S/UNI-622™ ATM Reference Design with Multimode Optics Errata

Issue 1: August 14, 1997

This document is the errata notice for Issue 3 of the S/UNI-622 reference design with multimode optics. It addresses transmit and receive clock terminations and interfacing timing issues in the S/UNI-622 reference design.

Figure 1. New values for the pullup and pulldown resistors

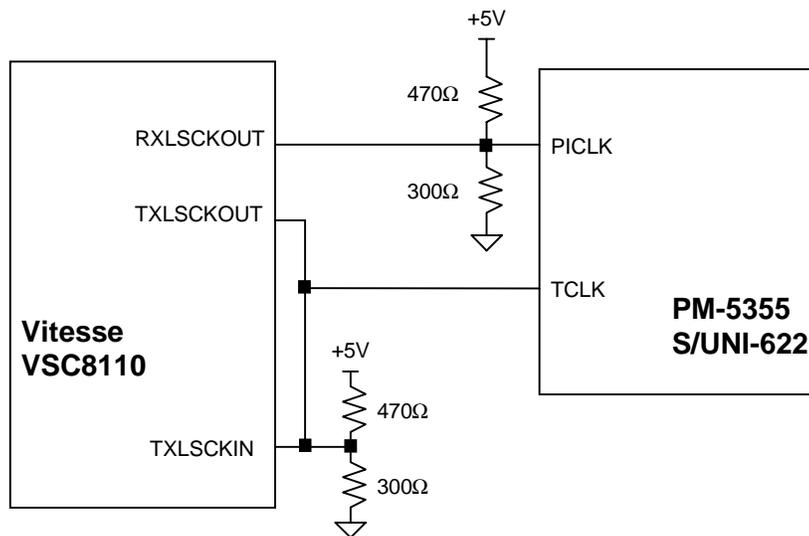
The Vitesse VSC8110 clock output loading presents a problem. The VSC8110 spec shows $V_{ol} = 0.5\text{ V}$ at 8 mA, and $V_{oh} = 2.4\text{V}$ at 2.4 mA. The original design has a 220Ω pullup resistor and a 330Ω pulldown resistor. V_{oh} does not present a problem, but V_{ol} would have to sink $(3\text{ V}-0.5\text{ V})/132\Omega = 18.9\text{ mA}$. This is 10.9 mA higher than what the VSC8110 can sink. To address the problem, the resistors should be changed to $470\ \Omega$ for the pullup one and $300\ \Omega$ for the pulldown one. Figure 1 shows the new pullup and pulldown resistors for both S/UNI-622's PICLK and VSC8110's TXLSCKIN terminations.

Figure 2 VSC8110 and S/UNI-622 Receive Interface Timing

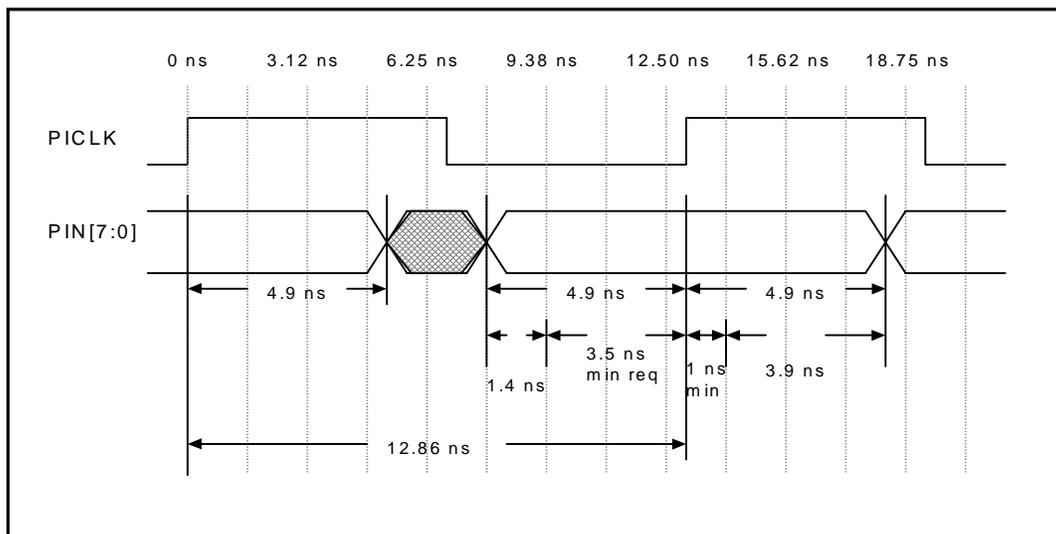
In the implementation section of sheet 2, S/UNI-622 Interconnect, on bottom of page 5, concerns were raised regarding to a 0.2 ns timing margin. This is shown as below. The entire section on the 0.2ns margin and the related timing diagram can be omitted since this timing requirement does not apply to the Vitesse VSC8110 and replaced with the following:

This identical timing exists with the FPIN input as well as the PIN[7:0]. Since there is only a 0.2ns timing margin on the setup time (data valid to the rising edge of clock) on the FPIN and PIN[7:0] inputs, precautions must be taken to avoid skew between these inputs. In fact, a slight delay (in the order of 1-5ns) in the data path would be advantageous and a slight delay (greater than 0.2ns) in the clock path would be intolerable. Hold time is not a concern on this interface since only 3ns are required and there are 11.9ns available. The Vitesse VSC8110 data sheet specifies that data is valid on RXOUT[7:0] at 4.9 ns before and after the rising edge of RXLSCKOUT. For the S/UNI-622, both the PIN[7:0] and FPIN has a setup time requirement of 3.5 ns and hold time of 1 ns. The Vitesse timing specification meets S/UNI-622's timing requirements with 1.4 ns margin for setup and 3.9 ns margin for hold time.

Figure 2 shows the new timing between the VSC8110 and the S/UNI-622.
